Chapter 3

Response to Comments on the Draft EIR and Recirculated Draft EIR

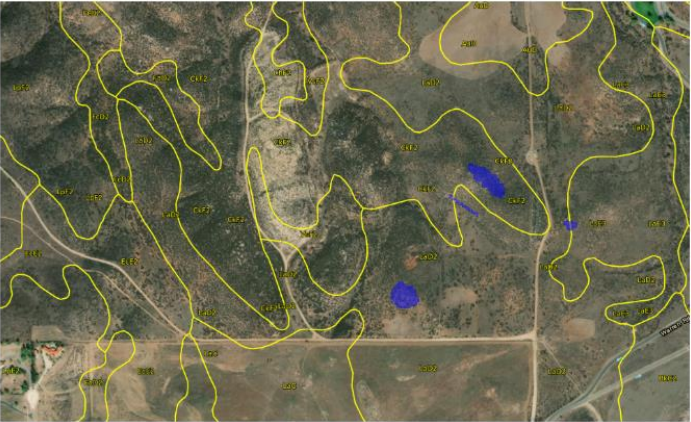
Comment#	Comment Text	Response
	larval host plant sites within the overall project site. The documents point out that some of the densest occurrences of QCB larval host plants would be conserved within proposed open space. But this is irrelevant to an assessment of impacts to the species' survival because QCB metapopulation biology depends less on concentrated patches of host plants than on dispersed larval resources in a diversity of geographic locations and ecological settings for long term metapopulation stability. In contrast to the EIR's assumptions, it is precisely dispersed (not densely concentrated) larval resources in a diversity of microclimate settings that support the resilience of QCB populations through climate fluctuations and other stochastic events. All QCB resources within the proposed Alternative H development footprint would be eliminated. Additionally, based on the 1 km rule (Preston, et al 2012), essentially all observed QCB adult and larval host plant sites within the proposed preserved open space, and extending into adjacent lands managed by other entities, would be at risk of extirpation. Insofar as the QCB population within the Project site and adjacent properties is integral to the larger Proctor Valley QCB metapopulation complex, Alternative H constitutes an existential threat to the Proctor Valley QCB metapopulation complex (see discussion of biology in earlier comment letters by Ballmer, Pratt, and Osborne dated April 28, 2015 and May 22, 2015). II. Proper alternatives are not offered. The EIR has not seriously considered project alternatives that might entail a different location, or a design that would substantially avoid or lessen adverse environmental impacts. As stated in the FEIR global response introductory remark section: Section 15126.6(b) of the CEQA Guidelines states that “the discussion of alternatives shall focus on alternatives to the project or its location which are capable of avoiding or substantially lessening any significant effects of the project, even if these alternatives would impede to some degree the attainment of the project objectives, or would be more costly.”

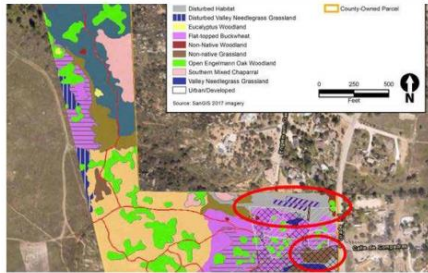
08-76	i. Water Supply An adequate and reliable water supply is crucial to the Project's longevity and operation of the Project, especially as California recently declared a drought in several counties—including San Diego. ²⁷ The DEIR reports anticipated demand of 16.4 million gallons/year. (DEIR, p. 4.1912.) The service boundary of the district water supplier, Padre Dam Municipal Water District (PDMWD), imports its entire potable water supply through San Diego County Water Authority and does not expect to meet demand through 2040 under dry year conditions. (DEIR, p. 4.19-2.) The DEIR shows that during normal conditions, supply will exactly equal demand in coming years. (<i>Ibid.</i> , Table 4.19-1)	This comment regarding the commenter's concern with the water usage of the proposed park is acknowledged. Please refer to MR-15 (Water and Wastewater) for more information about water supply and resources. The Draft EIR provided impacts and mitigation measures for the project area. Please refer to Chapter 4, <i>Environmental Analysis</i> , of the Draft EIR for a discussion of project implementation in relation to environmental impacts and mitigation measures. The Draft EIR takes a conservative, good-faith approach in its environmental analyses, often assuming the greatest level of future development. Please also refer to Section 4.19, <i>Utilities and Service Systems</i> , of the Draft EIR, which discusses the CEQA analysis, particularly

Comment#	Comment Text	Response
		any impacts for both water and sewer services. Impacts and mitigation measures are discussed in Section 4.19.4.3. Section 4.19.2.1 also discusses the water supply and service boundary of PDMWD. Please also refer to Section 4.10, <i>Hydrology and Water Quality</i>, of the Draft EIR, which states that the project would not substantially decrease groundwater supplies or interfere substantially with groundwater recharge. The entirety of PDMWD's potable water supply is imported through SDCWA. PDMWD's 2015 UWMP projects the estimated demand of potable water resources until the year 2040 based on coordination with various agencies, including SDCWA, which provided imported water availability and regional water demands and conservation, and SANDAG, which provided the most recent demographic projections (2050 Regional Growth Forecast Update Series 13). SANDAG's Series 13 projections were used instead of Series 14 projections to assume the greatest level of future development. Table 4.19-1 shows PDMWD's existing and projected water demand and estimated supply between 2020 and 2040 under normal weather conditions (PDMWD 2016). PDMWD's UWMP is updated every 5 years, at which time the projected supply and demand of potable water resources are reevaluated for the reasonably foreseeable future (i.e., 20-year planning period). The project would require an additional 50.5 acre-feet per year of water; however, water use would be reduced through water conservation measures identified in the UWMP. County DPR also received a water availability letter from PDMWD that confirmed adequate water supply would be available for the project site. Furthermore, the following mitigation measures will be implemented to ensure there would be adequate water supplies for operation of the proposed park during the life of the park. MM-UTIL-1 requires the completion of a water study to assess the capacity of the existing water infrastructure. If new or expanded water facilities need to occur, the County shall analyze potential environmental effects of the improvement in accordance with CEQA. MM-UTIL-2 requires the County to confirm water supply availability for development of the project

Comment#	Comment Text	Response
		prior to issuance of the building permit. No changes to the Draft EIR are needed.
08-77	The DEIR acknowledges a potentially significant impact to require new or expanded water facilities, “potentially requiring the relocation or construction of new or expanded water facilities” that could result in physical impacts. (DEIR, p. 4.19-14.) The DEIR claims mitigation under MM-UTIL-1, which simply requires it to complete a Water Study: “[P]rior to issuance of building permit,” DPR “shall coordinate” with PDMWD to assess capacity of existing infrastructure that would serve the site, and if insufficient capacity exists, “shall implement the necessary improvements prior to the operation of the project, as determined by PDMWD.” If the Project would result in need for new or expanded facilities, DPR shall analyze potential environmental effects of improvements in accordance with CEQA. (DEIR, p. 4.9-16.) This is classic piecemealing: segmenting the Project to avoid review in its entirety. Related water infrastructure requirements must be reviewed in conjunction with the Project—otherwise the Project’s impacts are obscured and minimized.	Please see the response to comment 08-76. For additional information on water supply assessment and wastewater, please see Section 4.19, <i>Utilities and Service Systems</i> , of the Draft EIR as well as MR-15 (Water and Wastewater). Please also refer to Section 4.10, <i>Hydrology and Water Quality</i> , of the Draft EIR, which states that the project would not substantially decrease groundwater supplies or interfere substantially with groundwater recharge. No changes to the Draft EIR are needed.
